Calculation Number: RWA-1313-001	Revision: 1	Total No. Pages (incl. cover): 22
Calculation Title: Cook Nuclear Plant AST Radiological Analysis Input Parameter Development		
Calculation Quality Classification: <input checked="" type="checkbox"/> Safety <input type="checkbox"/> Non-safety		
Verification Performed: <input checked="" type="checkbox"/> Review <input type="checkbox"/> Alternate Calculation <input type="checkbox"/> Testing		
Description: This calculation compiles plant input parameters for use in the Cook radiological analysis which is performed using the Alternative Source Term methodology. Revision 1 is performed to change the basis for the fraction of the primary-to-secondary leakage which flashes to steam on the secondary side of the steam generators. In addition, clarifying information has been provided regarding the VCT rupture isolation time.		
Digital Signature or Printed Name, Signature, and Date:		Applicable Sections:

Owner's Review Comments

Cook Nuclear Plant AST Radiological Analysis Input Parameter Development

RWA-1313-001, Rev. 1

Figure A1: Containment Sump Temperature Profile

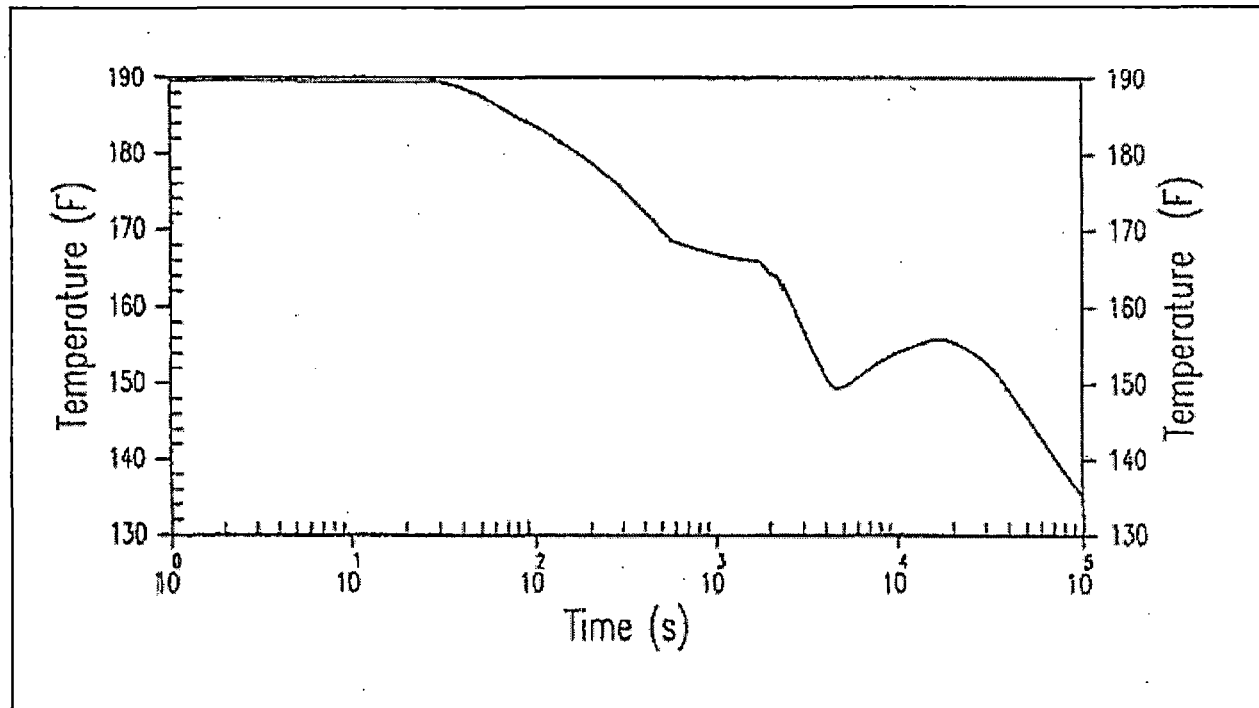
13	Figures A1 and A3	It may be prudent to darken the part of the plot that corresponds to the RCS pressure (the SG pressure is more prominent).	Footnotes were added to Figures A1 and A3 to emphasize that the figures contain traces for both RCS and Steam Generator pressures.	Acceptable. JJW-7/11/2014
14	Figures A2 and A4	Add "Hot Leg" to the title of the figure.	Figure titles have been revised	Acceptable. JJW-7/11/2014
